Flight Procedures Cover Page	Task Action: Abbreviated Amendment	Task Type: IAP	Estimated Chart Date: 12/24/2026	APWS Task ID: 48A1DA4B6D9C460C809826F8B950623A	APWS Project ID: 31EB9791B7AC44E3992DB305E61F2958
Procedure: RNAV (GPS) RWY 24 AMDT 1B		Enroute: NO	Specialist: Ferreira, Giorgia		Agreement Number:
Airport ID: KPTD			Airport City: POTSDAM		State: NY
Facility ID:	Facility Type:	Flight Inspection Remark Type:

RNAV (GPS) RWY 24

POTSDAM MUNI/DAMON FLD (PTD)

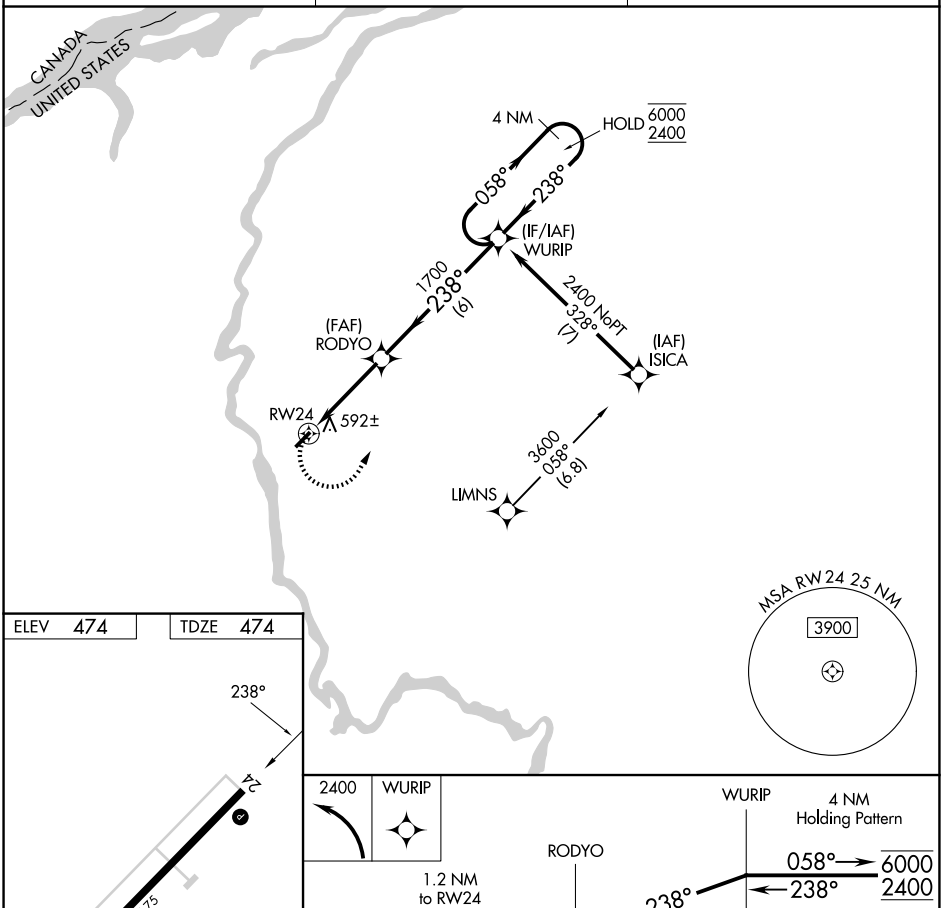
1. REMOVED 20:1 PENETRATIONS.
2. CHANGED HELICOPTER VISIBILITY NOTE FROM 1 SM TO 3/4 SM.
3. CHANGED 20:1 FROM NOT CLEAR TO CLEAR.
4. ADDED VDP.
5. DELETED CHART NOTE: STRAIGHT-IN RWY 24 NA AT NIGHT, CIRCLING RWY 24 NA AT NIGHT.
6. ADDED CHART NOTE VDP NA WITH MSS ALTIMETER SETTING.

Rwy 24 helicopter visibility reduction below ¾SM NA. VDP NA when using MSS altimeter setting. When local altimeter setting not recieved, use MSS altimeter setting and increase all MDA 80 feet; increase LNAV and Circling Cat C visibility ¼SM.
